## Answers to Q1 & 2

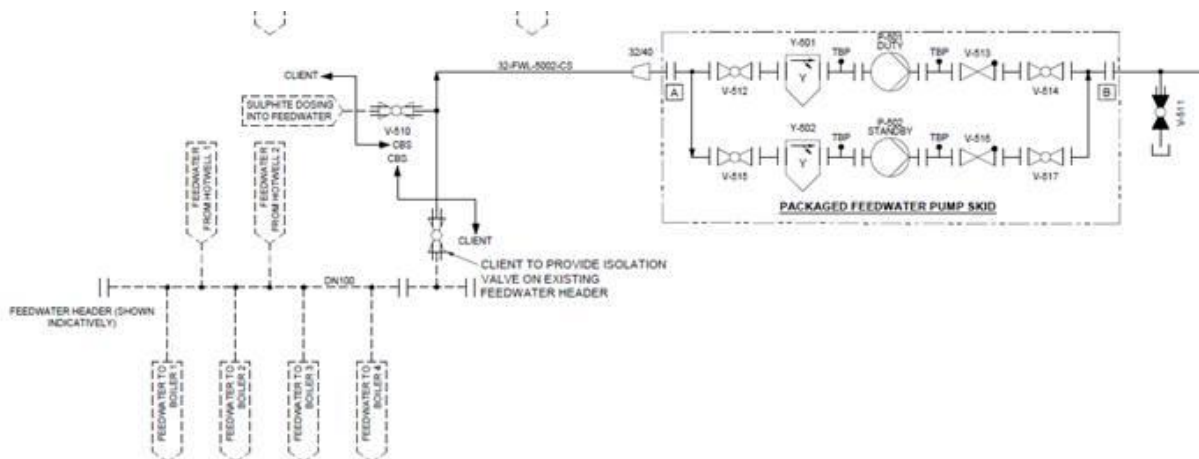
1. *For the WHB, the boiler feed water and chemical dosing is being provided by the Energy Centre. Please confirm the demarcation points for this specifically in relation to new feedwater pumps for the waste heat boiler and the supply of chemicals for this boiler.*

Please see the below snip from our schematic. Essentially, we will provide a valved DN25 tee on our feedwater line for sulphite dosing by TPI as shown below. There will also be a DN25 PN40 blanked flange on the WHB shell for future phosphate dosing by TPI. We will connect our feedwater line to a valved connection on the existing feedwater header to be provided by TPI as shown below.
